RE: NCC2019 Volume One Amendment 1 | Section J Energy Efficiency Part J1 Statement of Compliance

SUBJECT PREMISE: Mixed Use Community Centre | 28 Fisher Road & 9 Francis Street, Dee Why NSW 2099

JHA
MARKUP / SKETCH

DOCUMENT No.: 200320 - 28 Fisher Road Dee Why
DOCUMENT TITLE: NCC 2019 Section J Building Fabric Requirements
DOCUMENT REV: RevA
DOCUMENT BY: LY DATE: 20/08/2020

DRAWING TITLE
PROPOSED ROOFTOP LEVEL
DRAWING NO. **4089/1.8**
AMENDMENT **DA**

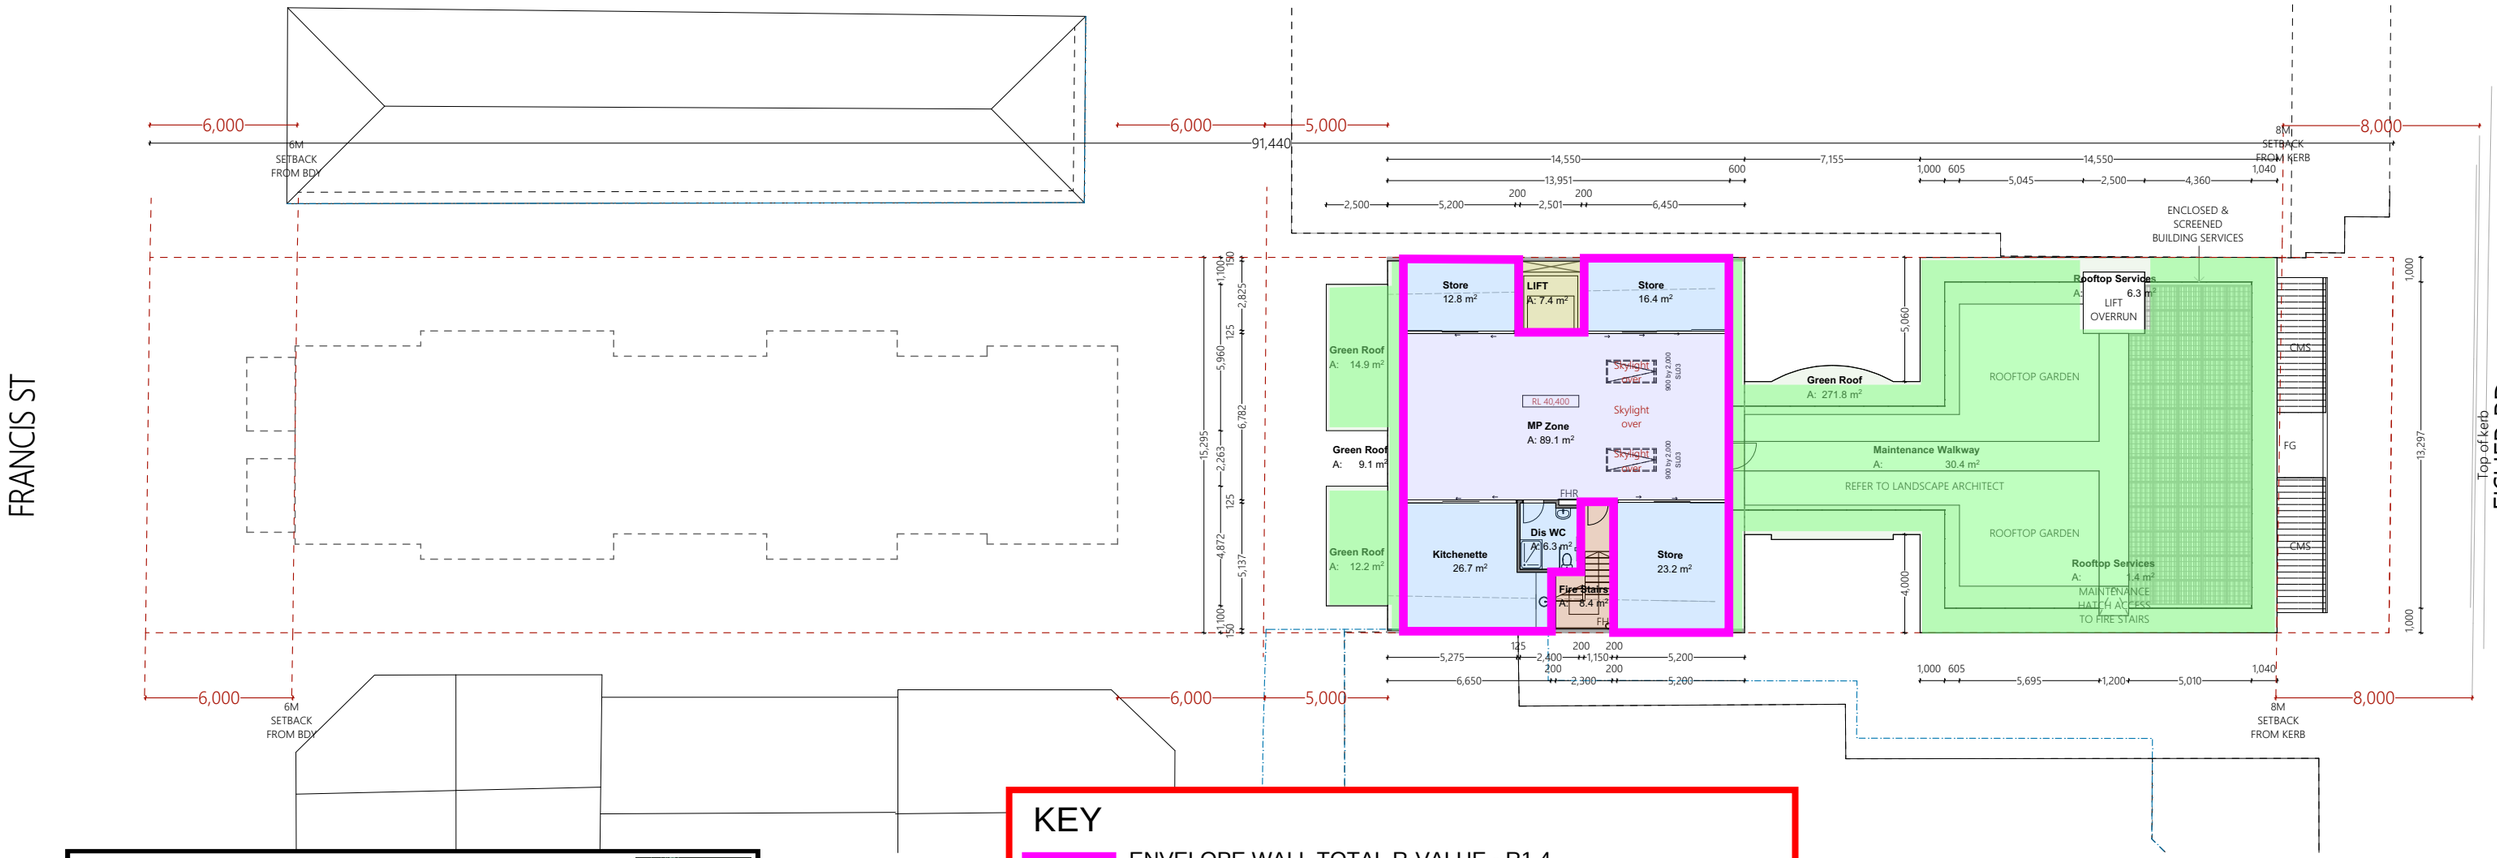
ENVELOPE WALL TOTAL R-VALUE - R1.4

ROOF TOTAL R-VALUE - R3.7 (Downward, SA < 0.45)

FLOOR TOTAL R-VALUE - R2.0 (Downward)

Notes:
1. It is a total system performance value and NOT the insulation.
2. The impact of Thermal Bridging must be included in the total system R-value calculations.
3. Roof Solar Absorptance (SA) must be no more than 0.45 (lighter colour)

DRAWING NO. **4089/1.9**
AMENDMENT **DA**

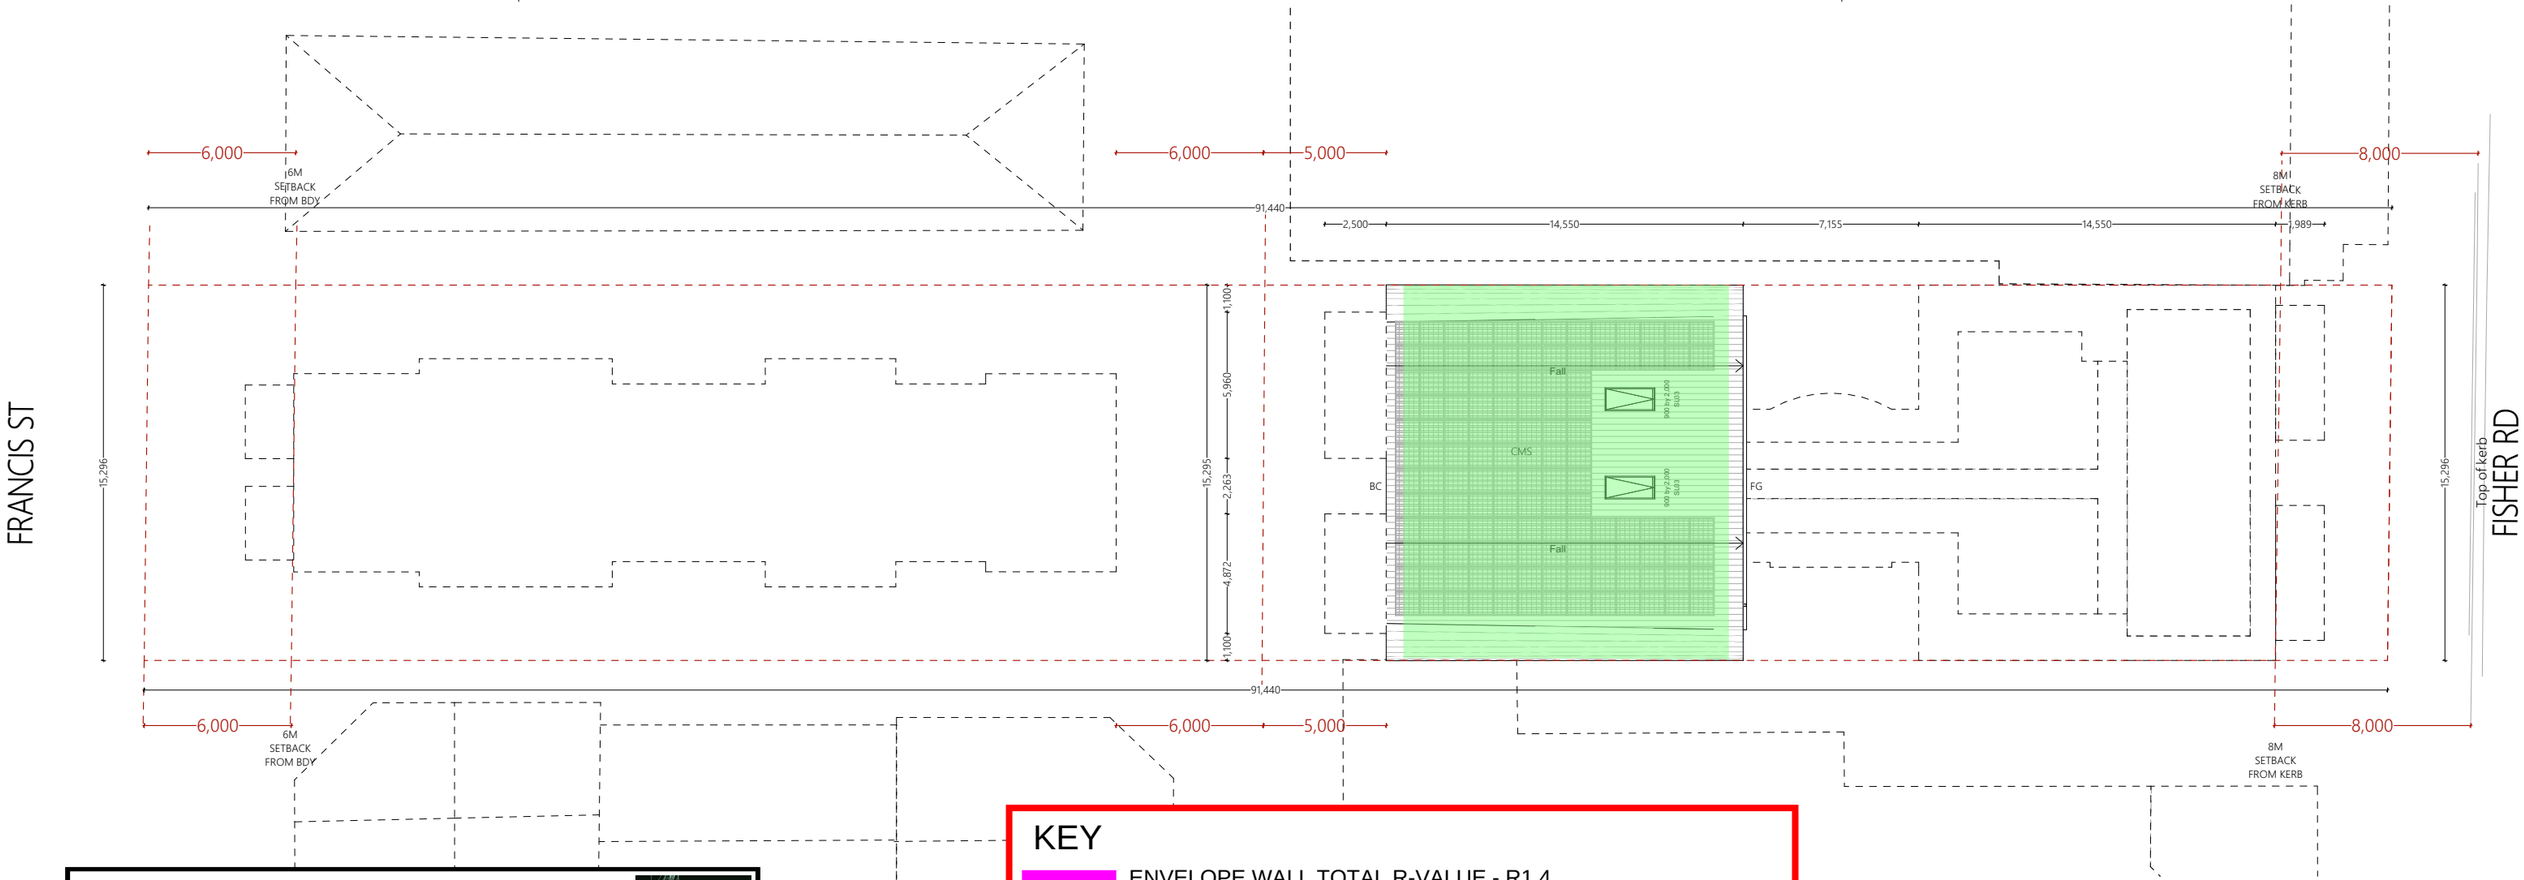
ENVELOPE WALL TOTAL R-VALUE - R1.4

ROOF TOTAL R-VALUE - R3.7 (Downward, SA < 0.45)

FLOOR TOTAL R-VALUE - R2.0 (Downward)

Notes:
1. It is a total system performance value and NOT the insulation.
2. The impact of Thermal Bridging must be included in the total system R-value calculations.
3. Roof Solar Absorptance (SA) must be no more than 0.45 (lighter colour)
